CERTIFICATE OF APPROPRIATENESS

Property: 7954 Glenvista Street, Lot 14, Block 19, Section 4, Glenbrook Valley Sec. 4 Subdivision. The property includes a one-story wood frame 1,645 square foot single-family residence situated on a 7,923 square foot corner lot.

Proposal: Alteration – Siding, windows, roof, porch

Recommendation: Denial of COA, issuance of COR **for work proposed**

ELEVATIONS
PREVIOUS EAST (FRONT)

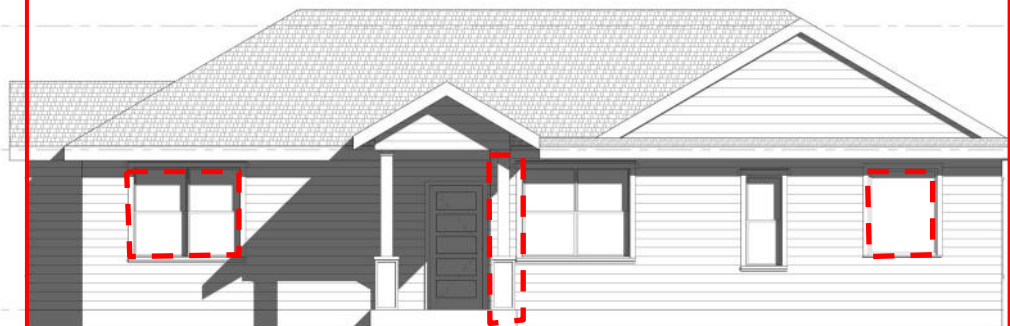
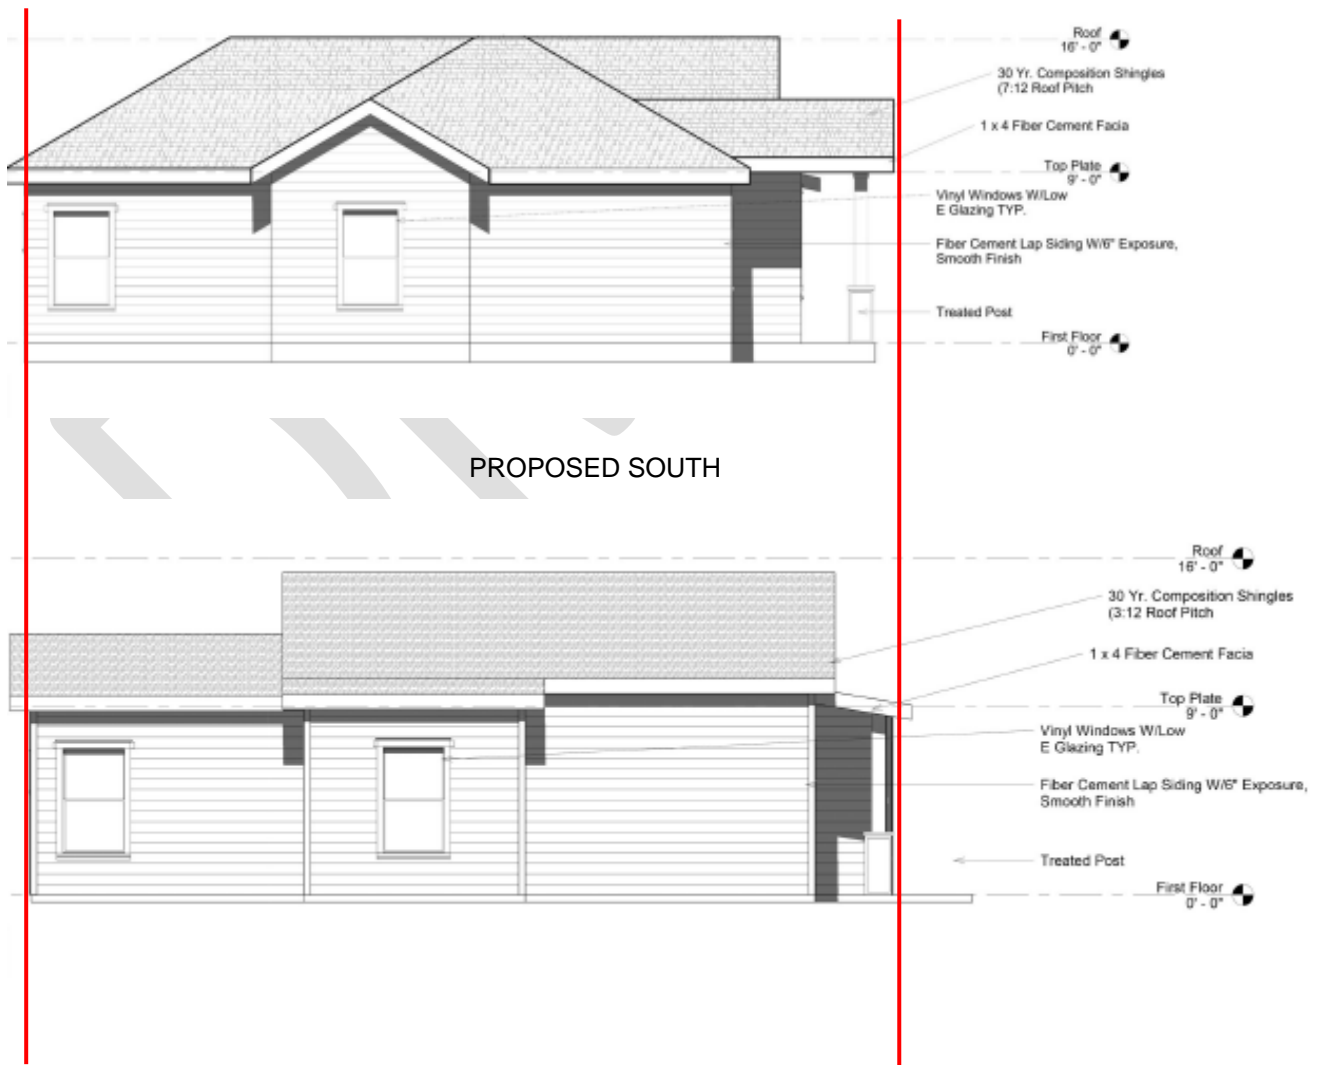
<i>The proposed work does not retain or preserve the historic character of the property.</i> |

<i>The proposed work creates an earlier appearance to emulate what was destroyed in the unpermitted work.</i> |

<i>The proposed work does not preserve the distinguishing qualities or character of the original structure.</i> |

<i>The proposed work does not maintain or replicate the exterior features that characterize the original structure.</i> |

<i>The proposed work would severely impair (and already has impaired) the form and integrity of the structure because work was completed first without COA or permits.</i> |

<i>The completed work destroyed the significant historical materials.</i> |
